HOSHIZAKI AMERICA, INC.

SERVICE BULLETIN

SB14-0001R3

SUBJECT: 4A4066-01 / 4A1726-33 (CS08KQE-PFV) COMPRESSOR CHANGE

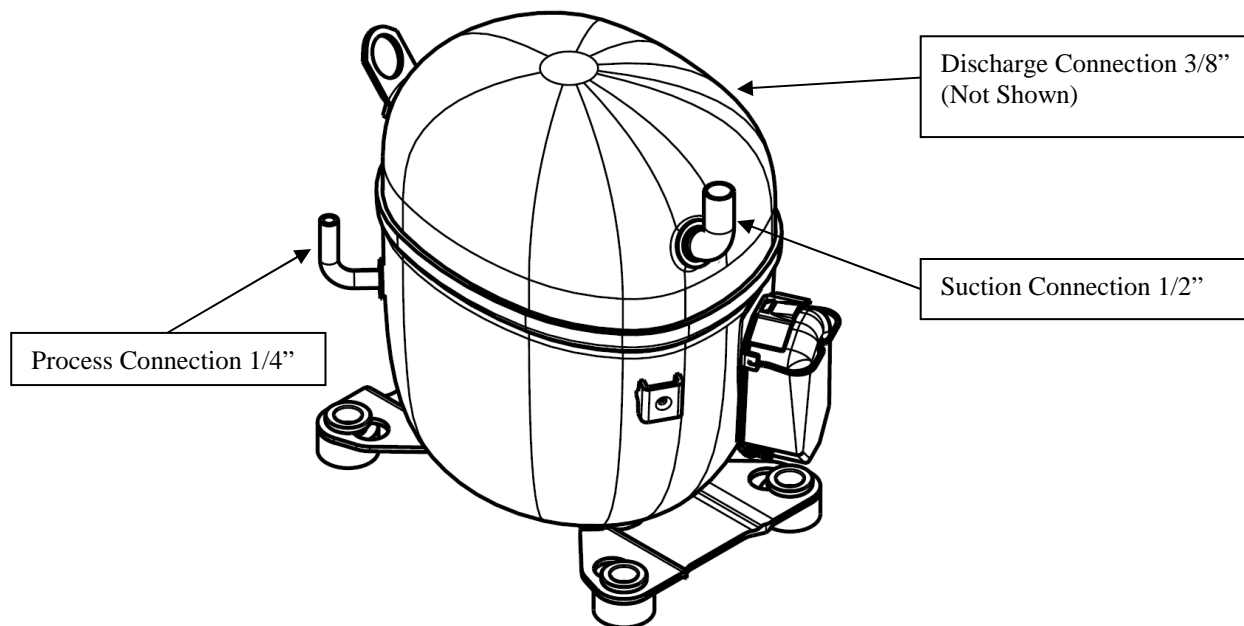
Although the footprint and the mounting of the compressors will be the same, this change will require connecting different size tubing and re-routing refrigerant lines. The suction fitting was 5/8" and is now 1/2", the process tube fitting was 3/8" and is now 1/4" and the discharge fitting remains 3/8". Use standard refrigeration practices to make the reduced connections. You may also have to lengthen the compressor leads during the changeover. See below for location of the ports on the replacement compressor.

Important: On KM models it is also recommended to **adjust DIP switches number 1 and 2 to the "ON" position** when making this conversion.
